Staff Report

Meeting Date: October 21, 2024

Project Name: Pho Real Rear, Enclosed Patio Addition

Case Number: COA24-0002

Figure 5: Proposed north elevation, 2399 W. Main St.

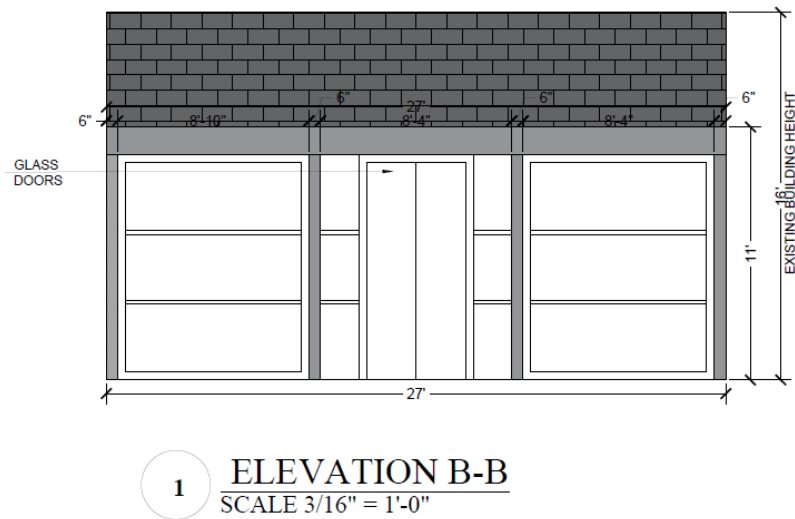
~~A 1ft overhang is proposed on all three elevations and sits at about 8ft above ground level.~~ *The applicant removed the 1 ft overhang on the east and west elevations, per recommendations from staff and the HPC, and kept the overhang on the north elevation.*

The elevations are not consistently divided vertically and instead are dependent on the width of the wall and inclusion of glass doors. ~~The north elevation features six vertical sections of glass with a 5ft wide double, glass door located on the center of the elevation. The vertical sections are 4ft 5 in wide, with the two sections closest to the doors being 1ft 8 in.~~ *The north elevation is divided into four vertical sections with a 5ft wide double, glass door located on the center of the elevation. This is a reduction from six vertical sections in the original submittal. The vertical sections are 8ft-4in wide, with the two sections closest to the doors being 1ft-8in wide. The measurements for this elevation are inconsistent between what is noted and the actual measurement based on the scale. The vertical section east of the door is noted as 8ft-10in wide, but when measured using the scale provided, the measurement is indicated as 8ft-4in wide. It appears the written measurement includes the 6in post when it should exclude it. **Measurements in the final submitted plan set will need to be accurate and consistent, prior to final issuance of the COA, should the HPC approve the application.***

Figure 6: Proposed east elevation, 2399 W. Main St.

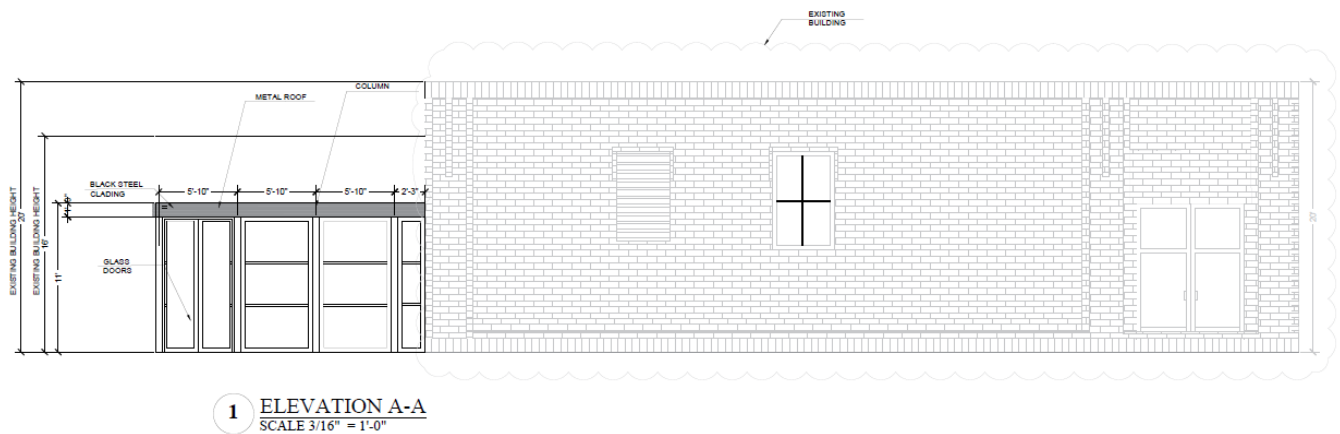
The east elevation is divided vertically into four sections, with three at 5ft-10in and the fourth, closest to the historic building, at 2ft-3in. The west elevation is divided into five vertical sections *with the northernmost section containing a double door that appears to be 5ft in width, as measured on the plans.* ~~with a 3ft 9 in, double glass door. The door is located on the north side of the elevation about 9.5 inches from the northeast corner of the addition. The remaining vertical sections, not adjacent to the doors, are 5ft-10in, with a 2ft-3in section closest to the building.~~

The proposed addition does not destroy historic materials that characterize the property. The proposed work is differentiated from the existing building and compatible. ~~in all areas except architectural features. The proposed 1 ft overhang on the west and east sides of the addition is not a compatible architectural feature. The overhang extends beyond the historic building and is not referential of any architectural feature on the building. The criterion is not fully met.~~ *The applicant removed the previously included 1ft overhang. This standard appears to be met.*

(ii) *The proposal is compatible with the main building. ~~except for the 1ft overhang on the east and west sides of the proposed addition. The overhang extends beyond the existing historic building on the east and west sides and is not a compatible architectural feature.~~*
